<b>DART AEROSPACE LTD</b>	<b>Work Order:</b> 79662
<b>Description:</b> Crosstube Assembly, Mid Fwd	<b>Part Number:</b> D206-667-147TRN
<b>Inspection Dwg:</b> D206-667-147 Rev: A	<b>Page 1 of 1</b>

<b>DART AEROSPACE LTD</b> HAWKESBURY, ONTARIO, CANADA	
DRAWING NO. D206-667-147	REV. A SHEET 1 OF 4
TITLE CROSSTUBE ASS'Y (206L MID FWD)	SCALE NTS
COPYRIGHT © 2010 BY DART AEROSPACE LTD THIS DOCUMENT IS PRIVATE AND CONFIDENTIAL AND IS SUPPLIED ON THE EXPRESS CONDITION THAT IT IS NOT TO BE USED FOR ANY PURPOSES OR COPIED OR COMMUNICATED TO ANY OTHER PERSON WITHOUT WRITTEN PERMISSION FROM DART AEROSPACE LTD.

DRAWING NO. D206-667-147	TITLE CROSSTUBE ASS'Y (206L MID FWD)	REV. A	<b>DART AEROSPACE LTD ENGINEERING ORDER</b>		D.E.O. NO. D206-667-147-A-1	SHEET NO. SHEET 1 OF 1	SCALE NTS
DRAWN 97	CHECKED AJS	MFG. APPR. [Signature]	APPROVED [Signature]		DE APPR. [Signature]		
DATE 11.07.15	DATE 11.07.20	DATE 11.07.21	DATE 11.07.21		DATE 11.07.21

REPLACE MAGNOBOND WITH PROSEAL.

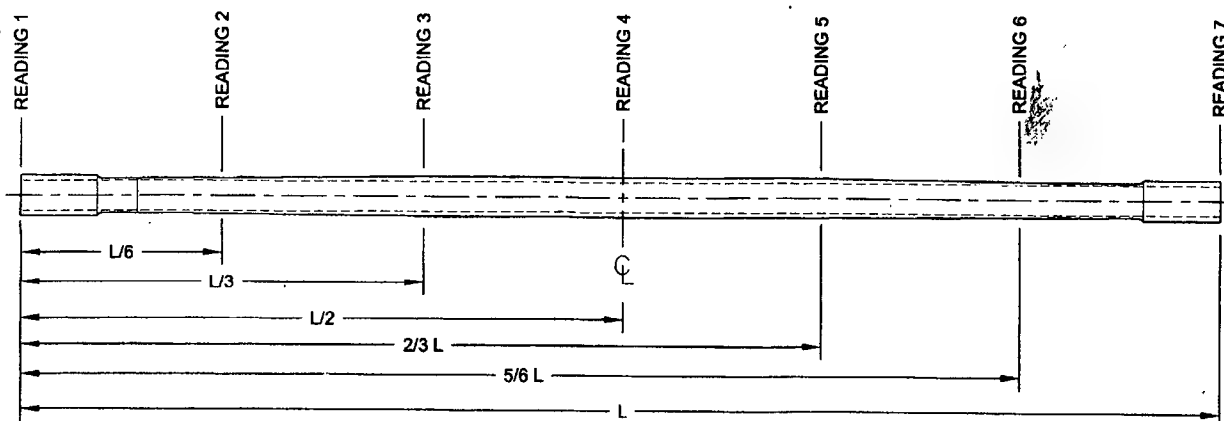
NOTE 12 & 15, SHEET 1 IS AMENDED AS FOLLOWS:

WAS:

- 12) INSTALL D2891-1 SUPPORT USING 0.03" TO 0.06" THICK LAYER OF MAGNOBOND 6398 PER QSI 015. LET CURE FOR 12 HOURS AFTER INSTALLATION AND PRIOR TO PACKAGING.
- 15) TORQUE CLAMPS 80 TO 100 IN-LB. ENSURE AT LEAST 1.5 THREADS SHOWING IN SAFETY AND THAT NUT HAS NOT BOTTOMED-OUT AFTER TORQUING.

Item	Qty -147	Part Number	Description
9	A/R	PROSEAL 890 B-2	SEALANT, AMS-S-8802 CLASS B-2

- 12) TO INSTALL D2891-1 SUPPORT: ABRASE MATING SURFACE OF SUPPORT AND CROSSTUBE WITH 180-GRIT SANDPAPER AND REMOVE RESIDUE WITH MEK (OR EQUIVALENT). APPLY A 0.04" TO 0.07" THICK LAYER OF PROSEAL 890 CLASS B-2 (OR AMS-S-8802 CLASS B-2) SEALANT TO MATING SURFACE OF SUPPORT.
- 15) TORQUE CLAMPS 80 TO 100 IN-LB. ENSURE AT LEAST 1.5 THREADS SHOWING IN SAFETY AND THAT NUT HAS NOT BOTTOMED-OUT AFTER TORQUING. **PRIOR TO PACKAGING, RE-CHECK TORQUE ON CLAMPS AFTER PROSEAL 890 SEALANT HAS CURED FOR 72 HOURS.**
